SUNDRY NOTICES AND REPORTS ON WELLS
Do not use this form for proposals to drill or to re-enter an abandoned well. Use form 3160-3 (APD) for such proposals.

Bridgecreek Resources respectfully requests approval for the following work-over for the Osprey 30-7 on October 4, 2016.

WELL NAME: Osprey 30-7
 FIELD: Verde Gallup
 LOCATION: San Juan County, NM
 API#: 30-045-35736
 AFE NUMBER: VG27DC
 SPUD DATE: 11/14/2015
 REVISION DATE: 09/19/2016

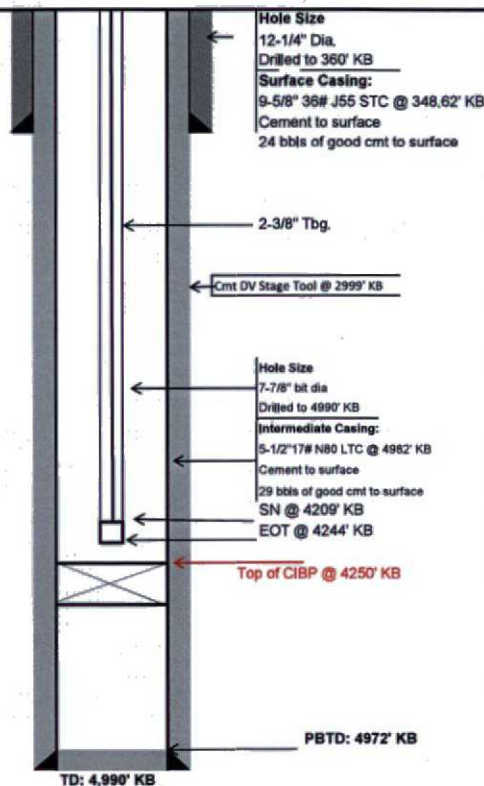
1. No activities may take place outside of the originally disturbed surface area.
2. The CIBP does not constitute permanent abandonment of the zones located below it.
3. Within 30 days of the workover, submit to this office a Sundry Notice, Subsequent Report of all activities that took place. **Provide flowrates and pressures of the new production.** Include a revised wellbore diagram with the perforations and name of the zones on the diagram. These should be with the drawing and not as an attached table.
